United States Patent and Trademark Office

APPLICATION NO.	FILING DATE	FIRST NAMED INVENTOR	ATTORNEY DOCKET NO.	CONFIRMATION NO.	
10/562,231	12/21/2005	Pascal Benoit	PF030105	5461	
7590 08/10/2006			EXAM	EXAMINER	
Joseph S Tripoli			CHAPEL, DEREK S		
Thomson Licensing Inc					
Patent Operations			ART UNIT	PAPER NUMBER	
PO Box 5312			2872		
Princeton, NJ 08543-5312			DATE MAILED: 08/10/2006

Application No.	Applicant(s)				
	10/562,231	BENOIT, PASCAL				
Office Action Summary	Examiner	Art Unit				
	Derek S. Chapel	2872				
The MAILING DATE of this communication appears on the cover sheet with the correspondence address Period for Reply						
A SHORTENED STATUTORY PERIOD FOR REPLY IS SET TO EXPIRE 3 MONTH(S) OR THIRTY (30) DAYS, WHICHEVER IS LONGER, FROM THE MAILING DATE OF THIS COMMUNICATION. - Extensions of time may be available under the provisions of 37 CFR 1.136(a). In no event, however, may a reply be timely filed after SIX (6) MONTHS from the mailing date of this communication. - If NO period for reply is specified above, the maximum statutory period will apply and will expire SIX (6) MONTHS from the mailing date of this communication. - Failure to reply within the set or exte

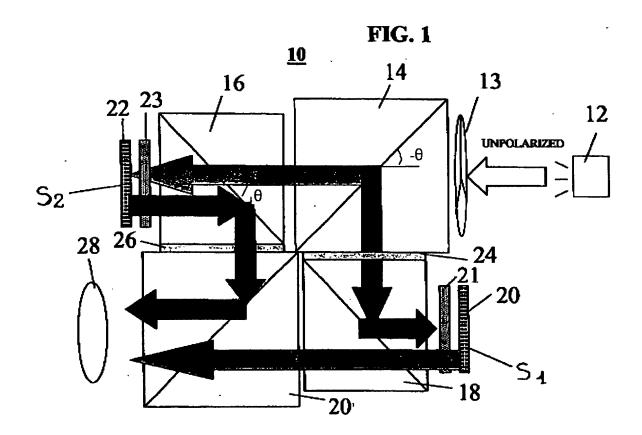
19. As to claims 3/2 and 3/1, O'Donnell teaches the combinations of claims 1 and 2, in which the splitting surface of the first polarization splitter makes with the light beam an angle having a defined value in a first plane containing the light beam and in which the splitting surface of the second polarization splitter makes with the light beam an angle having an opposite value to the defined value in a second plane containing the light beam and parallel to the first plane (See specifically θ , $-\theta$ in Fig. 1 below as edited by the examiner).

- 23. As to claims 14/13, 14/12 and 18, O'Donnell teaches the combination of claims 12, 13 and 16, in which the splitting surface of the first polarization splitter makes with the light beam an angle having a defined value in a first plane containing the light beam and in which the splitting surface of the second polarization splitter makes with the light beam an angle having an opposite value to the defined value in a second plane containing the light beam and parallel to the first plane (See specifically θ, -θ in Figure 1, as edited by the examiner, in section 19 of this office action).
